<b>Title - Sujet</b> Steveston (Gulf) Re-Dredging	
<b>Solicitation No. - N° de l'invitation</b> F1571-165032/A	<b>Amendment No. - N° modif.</b> 002
<b>Client Reference No. - N° de référence du client</b> F1571-165032	<b>Date</b> 2016-08-25
<b>GETS Reference No. - N° de référence de SEAG</b> PW-\$PWY-033-7845	
<b>File No. - N° de dossier</b> PWY-6-39118 (033)	<b>CCC No./N° CCC - FMS No./N° VME</b>
<b>Solicitation Closes - L'invitation prend fin</b> <b>at - à 02:00 PM</b> <b>on - le 2016-08-30</b>	<b>Time Zone</b> Fuseau horaire Pacific Daylight Saving Time PDT
<b>F.O.B. - F.A.B.</b> <b>Plant-Usine:</b> <input type="checkbox"/> <b>Destination:</b> <input checked="" type="checkbox"/> <b>Other-Autre:</b> <input type="checkbox"/>	
<b>Address Enquiries to: - Adresser toutes questions à:</b> Siopongco, Philip PWY	<b>Buyer Id - Id de l'acheteur</b> pwy033
<b>Telephone No. - N° de téléphone</b> (604) 351-6139 ( )	<b>FAX No. - N° de FAX</b> ( ) -

**Addendum 002**

**F1571-165032**

Addendum 002 is raised to:

DATE: Wednesday, June 22, 2016					
				JOB NUMBER	DWG.				
		DESCRIPTION:	BATHYMETRIC MONITOR	3-16-008_80-01-102	PLN-001

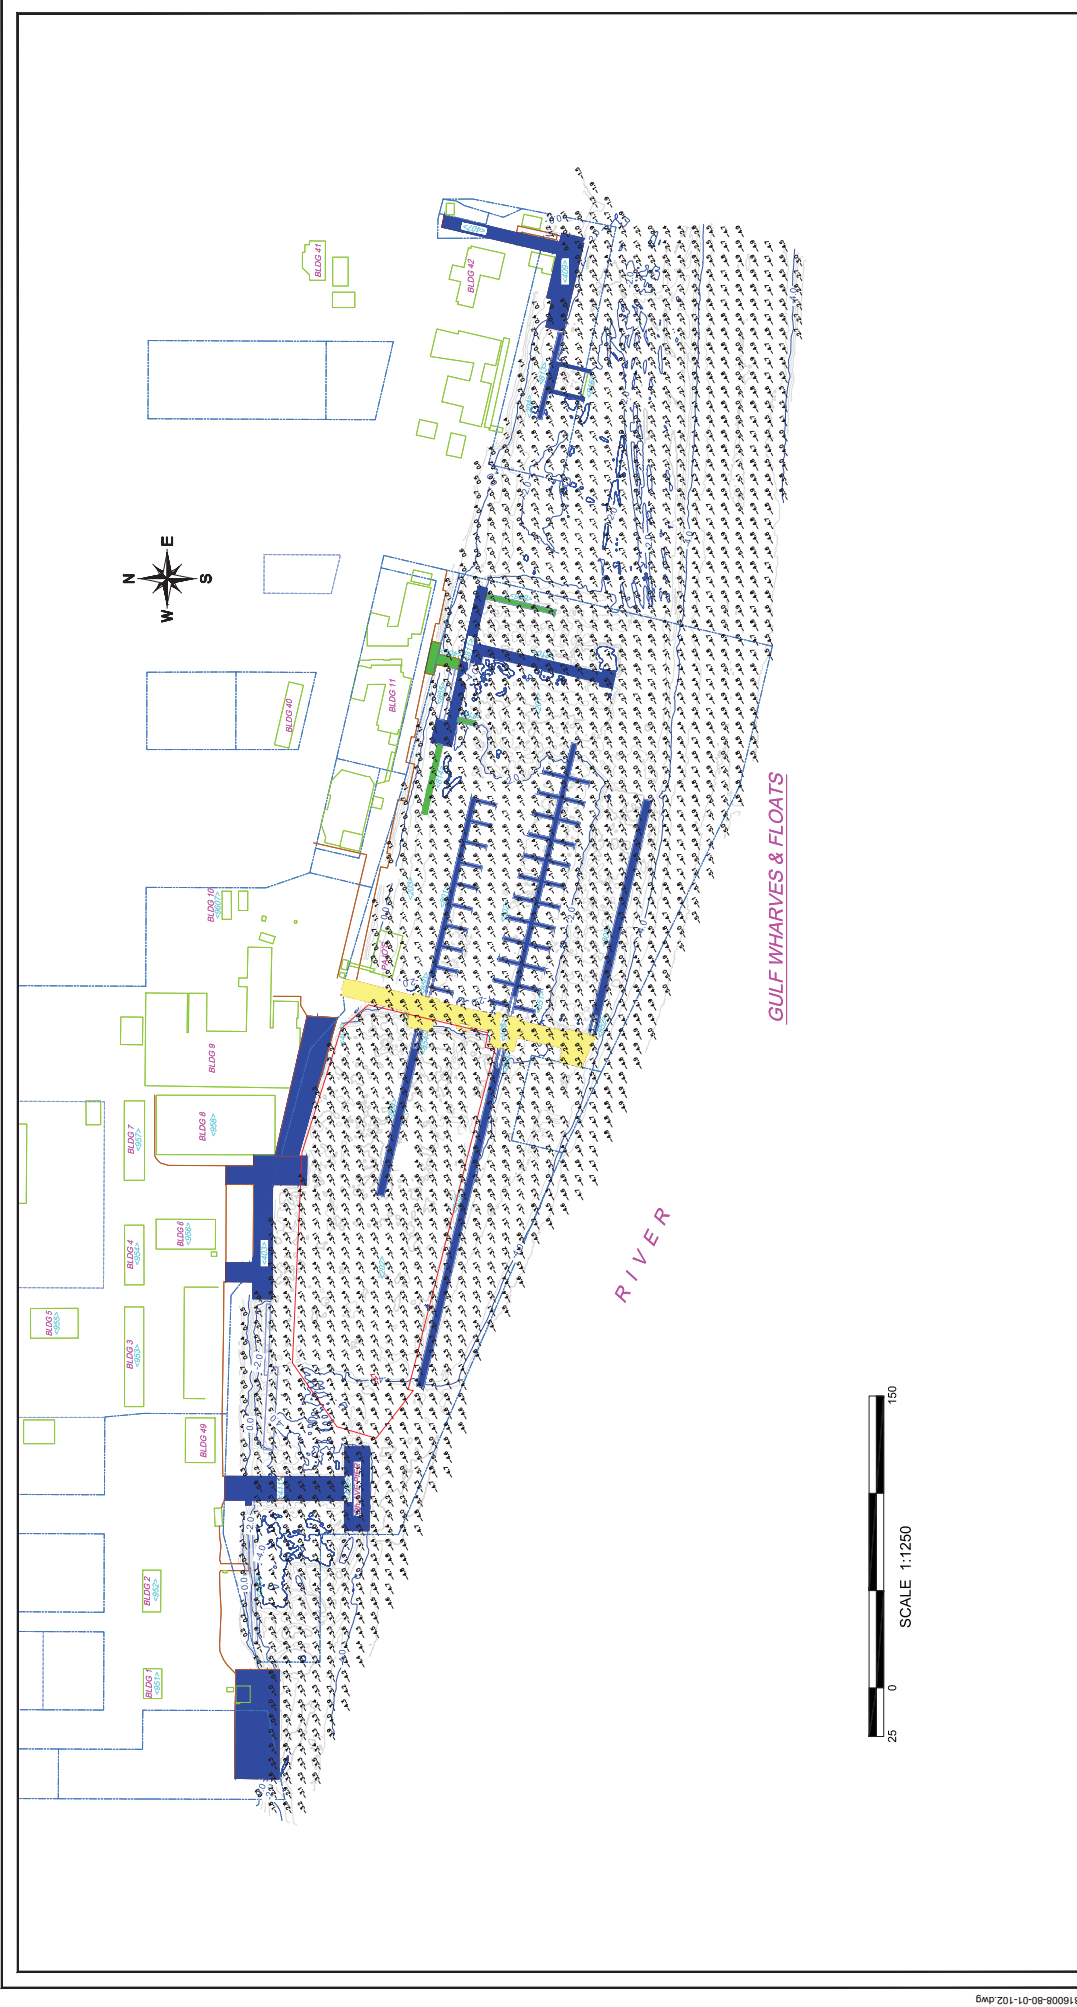
**Q1)** Will a current sounding survey of the dredge site be provided prior to the tender closing date?

**A1)** Yes, see attached sounding survey 316008-80-01-102-ISO A1 Survey-rlp.
